CITY OF PATASKALA BOARD OF ZONING APPEALS

STAFF REPORT

Transportation Corridor Overlay District TCOD-22-002

TCOD-22-002 Staff Review

**PROVISION LIVING
CITY OF PATASKALA
OVERALL SITE PLAN**

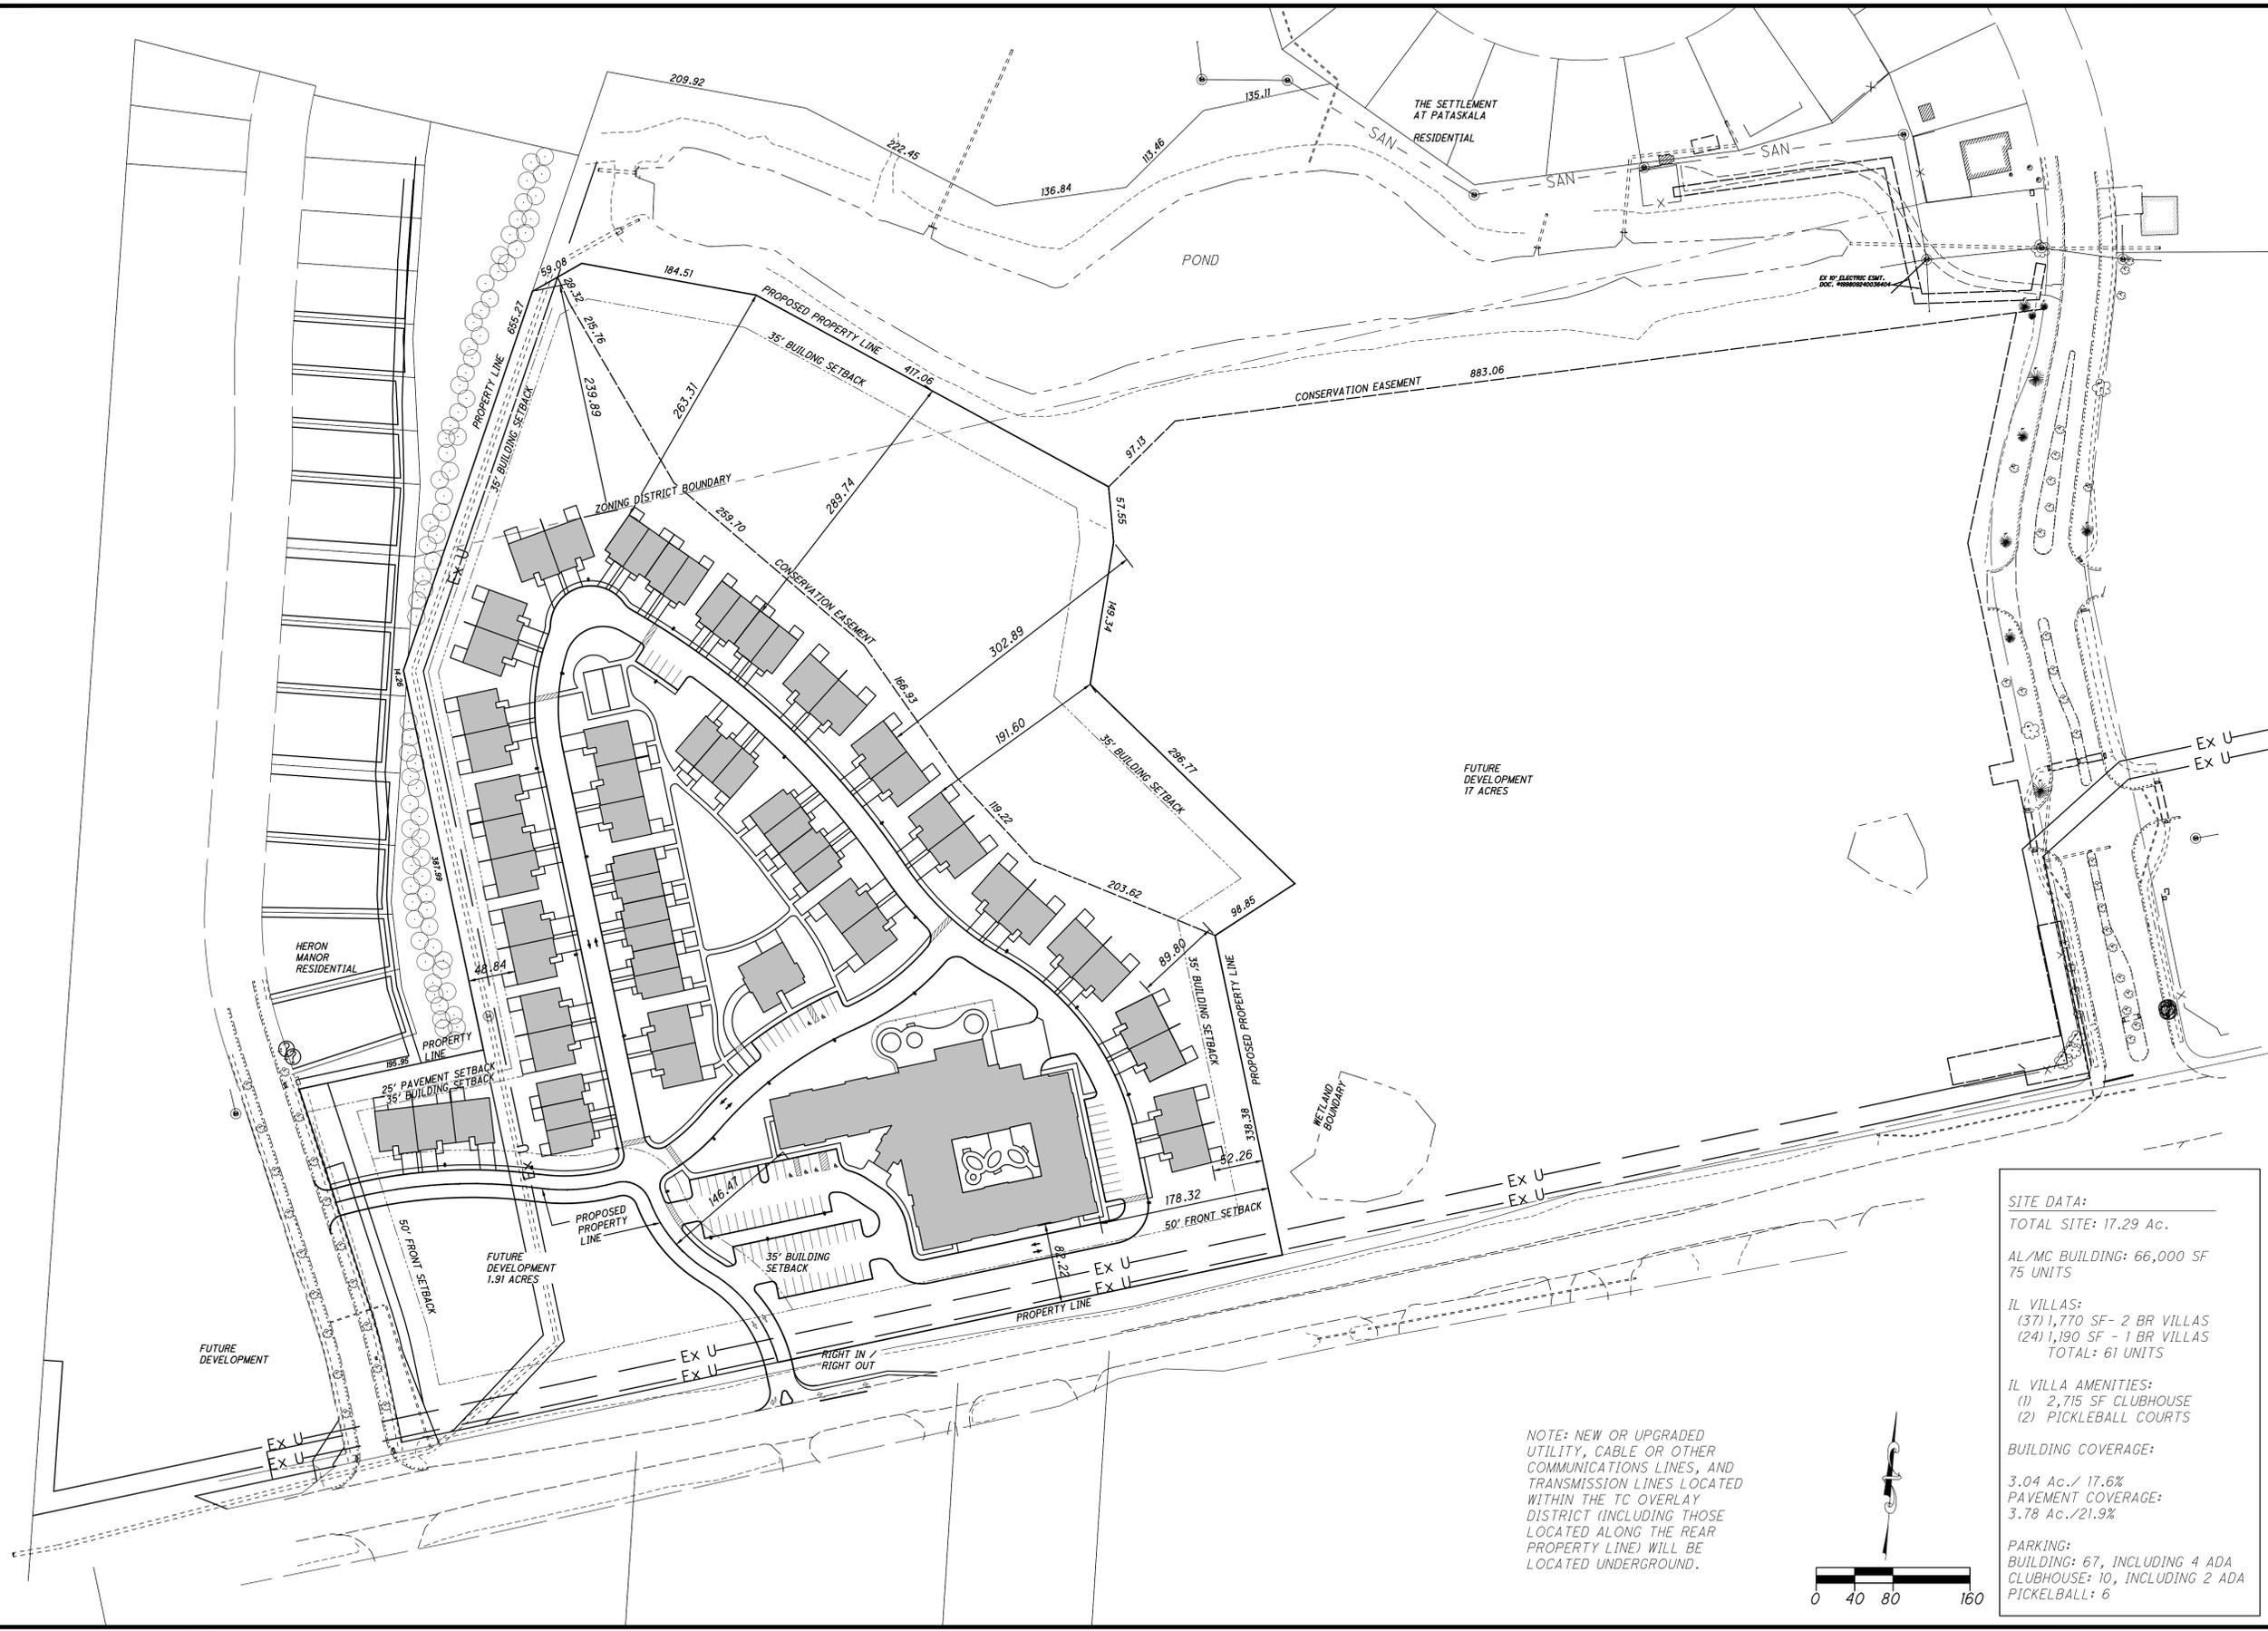
- ILV's on the far north side shall not extend beyond the zoning boundary.
 - Again, just a note to keep in mind.
- Indicate Zoning District boundaries on the site plan.

- **Label GB and R-10**
- Include property line dimensions.
- ~~“Wetland Boundary” should be revised to “Conservation Tract” to reflect what it is platted as.~~

- Include a “Notes” section of page 1.
 - **Include note for all interior roadways to be private.**
- ~~Include widths of interior roadways, radius of eyebrow~~

- **Minimum setback from R/W is 10'. Please indicate distance from public R/W. 8' is shown from private road but setback only applies to public R/W.**

- Again, just a note to keep in mind.
- **For Private Access (shared with SW corner lot): Will need some sort of maintenance agreement and common access agreement/easement.**

- *1249.05(C)(2): Side Yard shall be 35' for buildings, and 25' for paved areas when abutting a residential zoning district.
 - With the new information that the SW corner will be separated, that makes the property line down the centerline of the private road become a new Side Yard lot line. 35' setback shown, indicate actual distance for westernmost units, unit at corner.

- Indicate type of refuse disposal for Independent Living Villas. Will each unit have its own trashcan (typical residential trashcans) or will there be a central dumpster location? Indicate as a note on the first page.

- I believe the intent was for individual trash cans when we spoke earlier. Indicate so with a note on the plans.

**PROVISION LIVING
 CITY OF PATASKALA
 DEVELOPMENT PLAN**

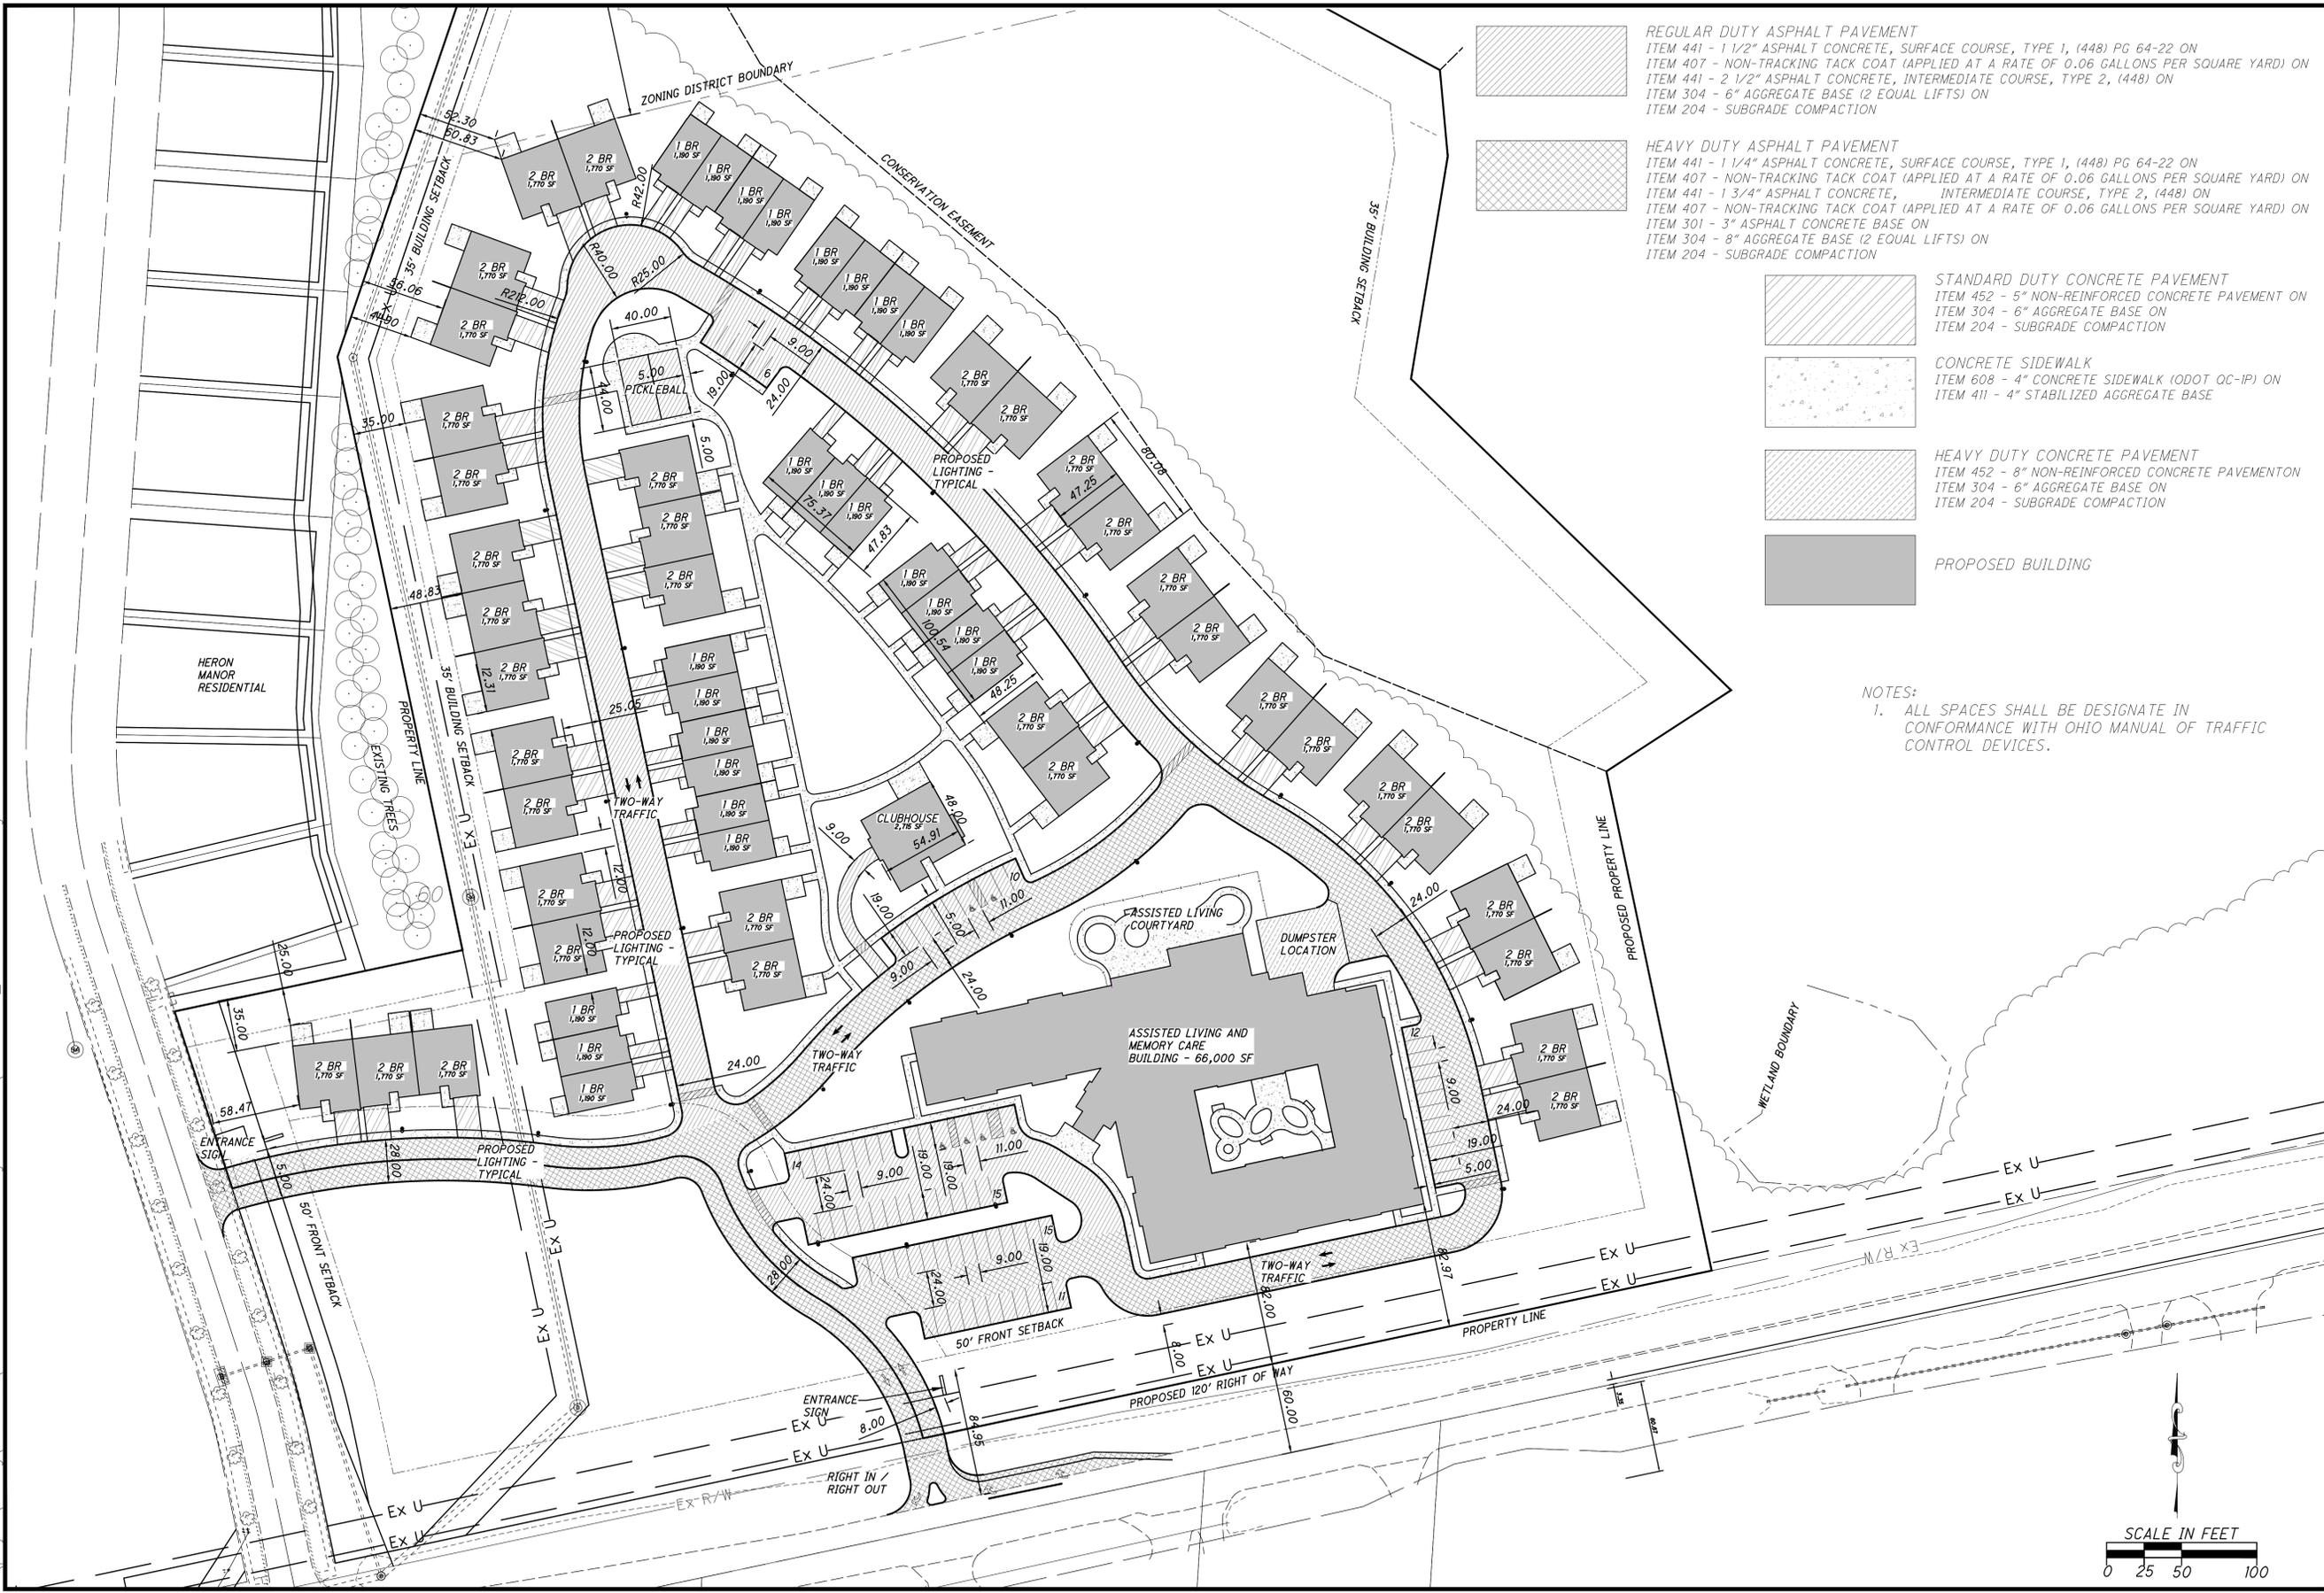
- ~~Fee in lieu possible.~~
- 1259.06 – Site Design Submittal Requirements
 - 1259.06(1): Site Plan – Following information must be shown on the plans.
 - **1259.06(1)(a): The boundaries and dimensions of the lot.**

- **Missing front on Broad and Heron.**
 - ~~1259.06(1)(b): Size and location of existing and proposed structures.~~
 - ~~Please show the exterior dimensions of the AL/MC building on the elevation pages.~~

- Locations and types of lighting required to be shown. Recommend including photometric plan.
 - Independent Living Villas: Will there be streetlights/front yard light posts, lights on the front of buildings/no lighting? Need information.

- Show dimensions of access aisle somewhere.
 - ~~1291.07(C): All spaces shall be designate in conformance with Ohio Manual of Traffic Control Devices.~~
